BUILDING AMERICA®

Re: Docket No. FD 36854, Union Pacific Railroad Company – Construction and Operation Exemption – in Matagorda County, Texas; Response to Information Request No. 1

25% PRELIMINARY PLANS
NOT FOR CONSTRUCTION

RCR Rail – Proposed location previously green, closer image here referenced in [blue](#).

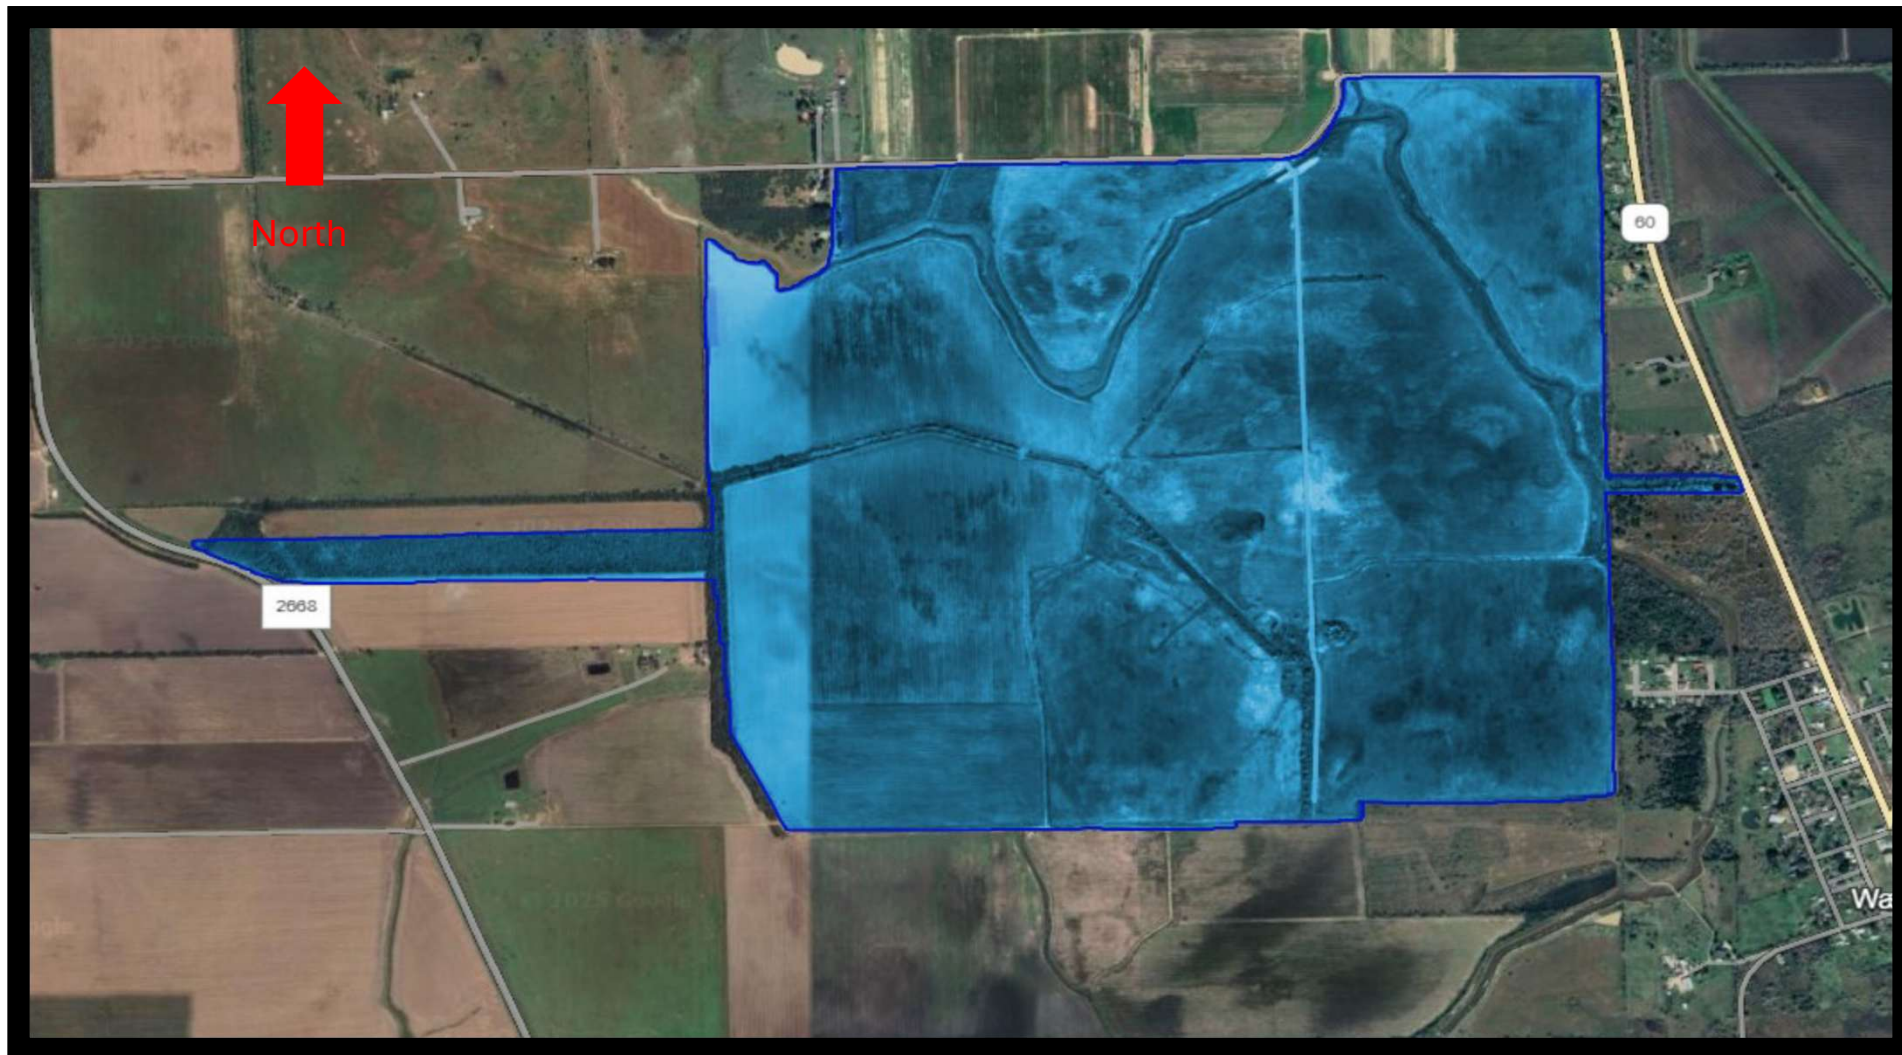
3.B. REQUEST: Provide a brief description and map of the approximate location, if available, of the potential industrial park located south of Gilmore Road and north of the LyondellBasell facility.

3.B. RESPONSE: An independent developer, RCR Rail, is proposing to construct an industrial park to locate new industries and to provide rail car storage for nearby customers. Similar to other facilities in the area, they are looking to create capacity and storage for customers in this vicinity of rapid customer growth. See attached PDF titled "RCR Rail location."
